Description of Changes

Item	Main board_Front		Main board_Rear	
Before				
After

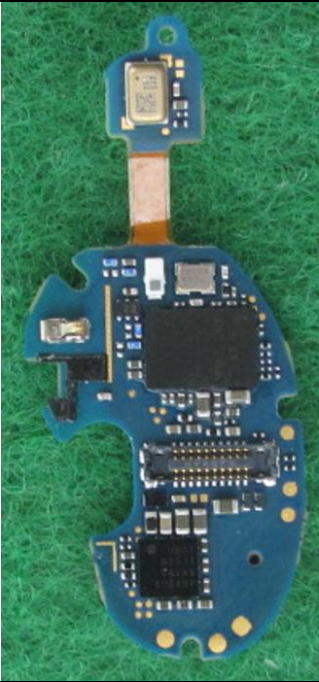
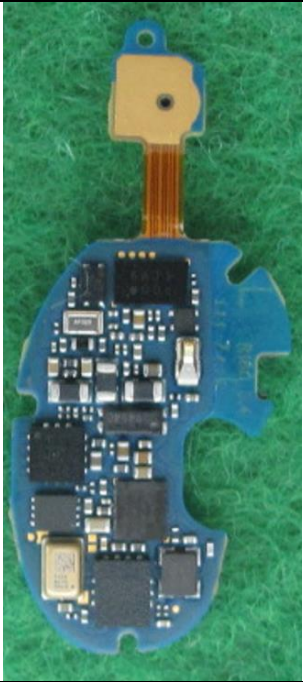
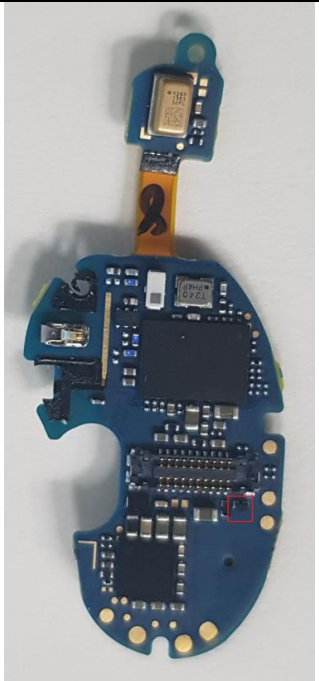
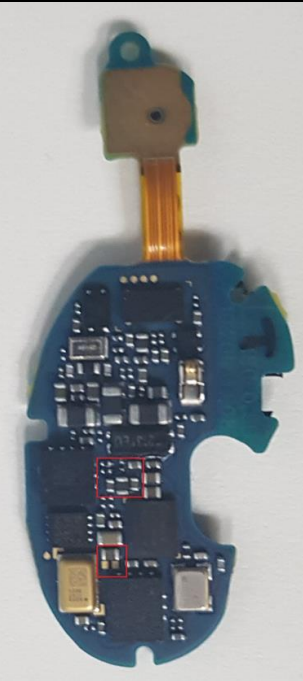
Item	Antenna_Left	Antenna Gain
Before		-7.3 dBi
After		-7.5 dBi

- There is change of the antenna pattern.
Equivalent antenna.
 - Lower antenna gain.
 - Same antenna type.
- There is minor change in PCB layout.
Minor change in PCB layout does not affect to radio performance.
